NOTES: (UNLESS OTHERWISE SPECIFIED)		PARTS LIST	
1. DO NOT SCALE FROM DRAWING.		DIMENSIONS ARE IN MILLIMETERS	
2. REMOVE ALL SHARP EDGES, R5 MIN.		TOLERANCES: X ± 0.1 XX ± 0.05	
		ANGULAR ± 0.2°	
		MATERIAL 6082-T6 Al	
		FINISH -- μ inch	
		DRAWN R. JONES	
		CHECKED M.P. LLOYD	
		APPROVED	
		DATE JAN 08	
		SIZE C	
		DWG. NO. D080041	
		SCALE: 1:1	
		PROJECTION: 1st Angle	
		SHEET 1 OF 1	
		CALIFORNIA INSTITUTE OF TECHNOLOGY MASSACHUSETTS INSTITUTE OF TECHNOLOGY IGR, GLASGOW UNIVERSITY GEO 600 GROUP	
		SYSTEM ADVANCED LIGO	
		SUB-SYSTEM SUS	
		NEXT ASSY CO2 Laser Machine	
		PART NAME Mounting Bracket	
		REV. 01

DETAIL A
NOTE: RE-MACHINING OF BRACKET FROM REV-00 TO REV-01, DESCRIBED BY "DETAIL A"

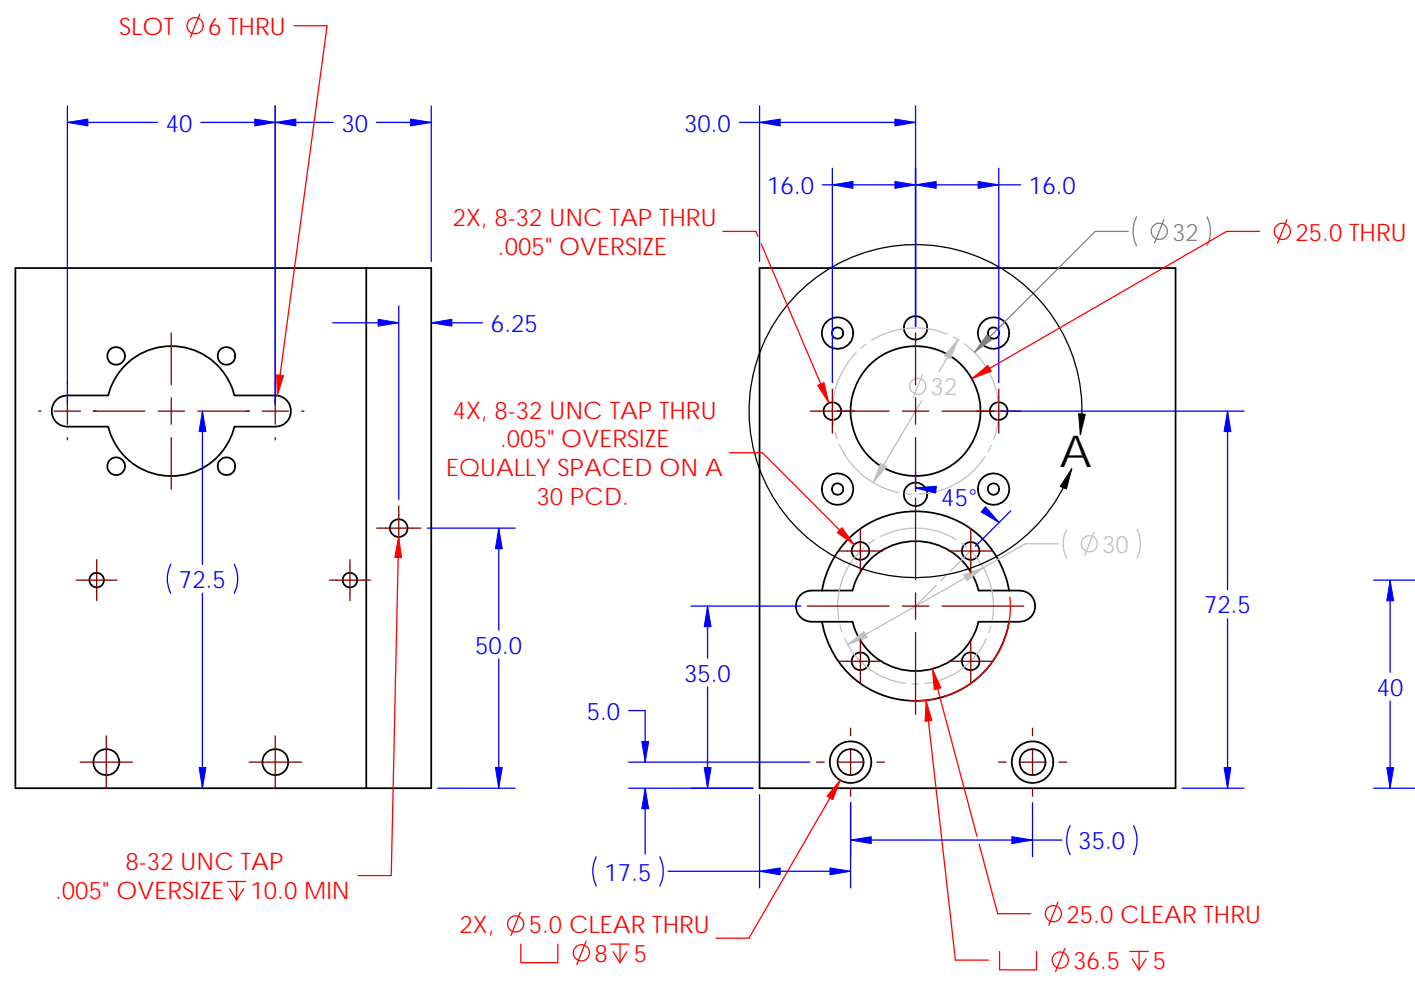
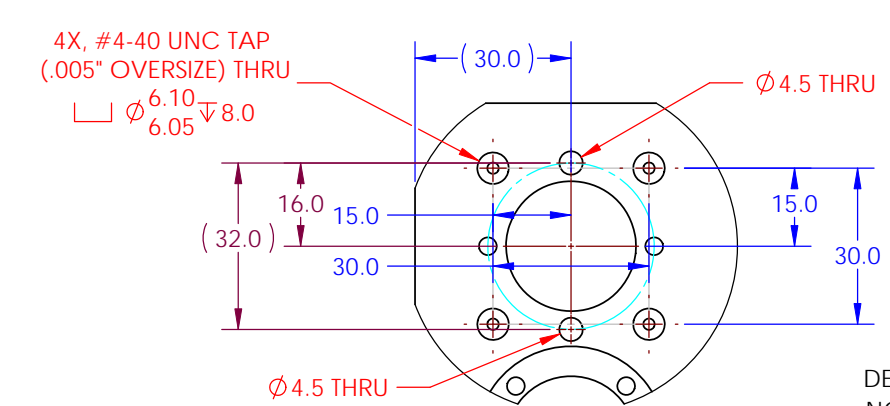
REV.	DATE	DCN #	DRAWING TREE #
00	SEPT07	INITIAL RELEASE (R.JONES)	
01	MAY08	RE-MACHINING DESCRIBED BY "DETAIL A" (R.JONES)
